## **Pre-Application Summary Sheet**

Application Number: PMTG-2025-0220; Lane Farm Project

The applicant would like to subdivide PIN 179-169-392-000 and 180-493-346-000.

Subdivision Plan for Rural Cluster Residential Development in the AR-1 Zoning District

Figure 1: Route 15/Spinks Ferry Roundabout and Realignment of New Valley Church Road

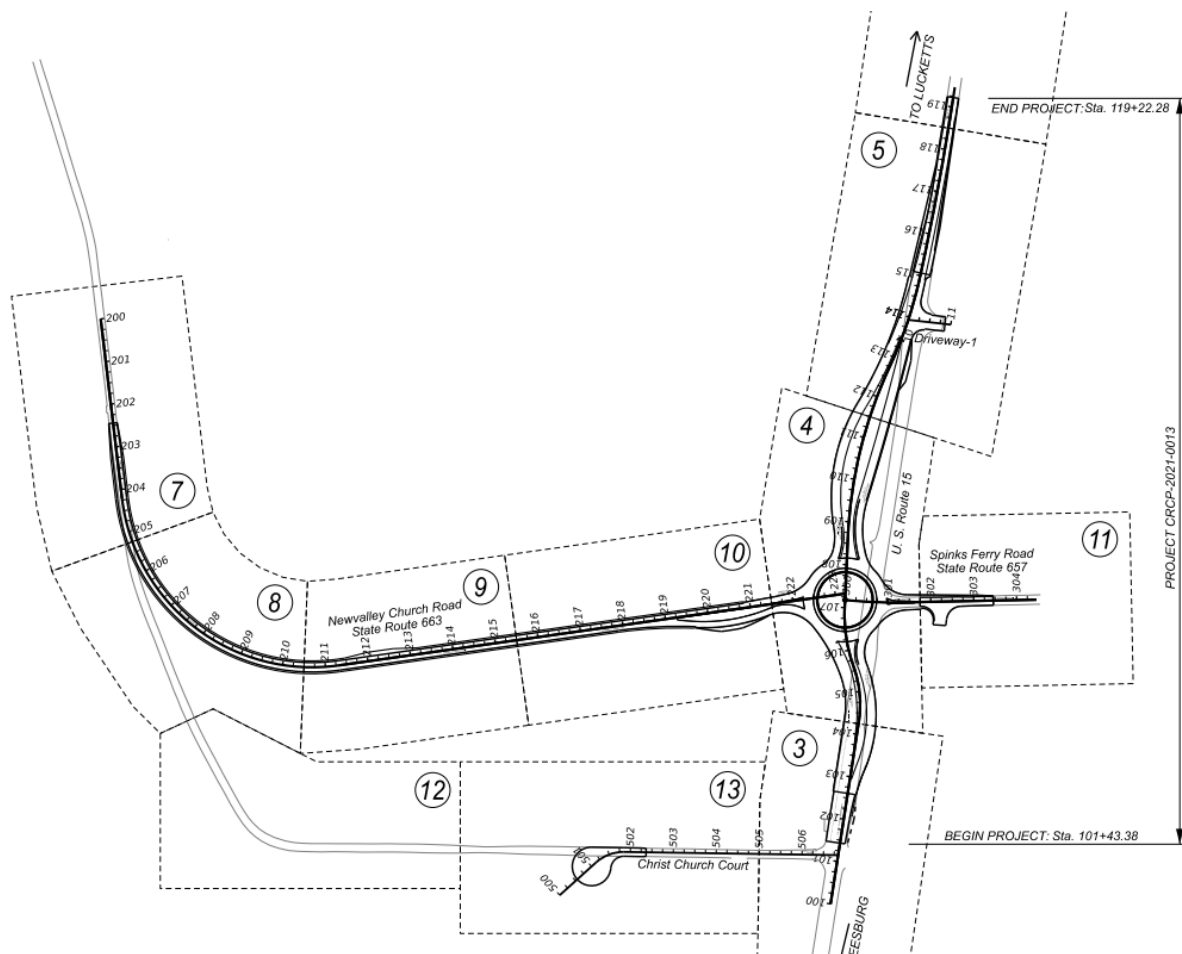
**Route 15/Spinks Ferry Roundabout (CRCP-2021-0013)** right-of-way would be needed on the subject property to accommodate this. Existing New Valley Church Road will become a cul-de-sac and realign to the north per CRCP-2021-0013. (See below Figures 1 and 2).
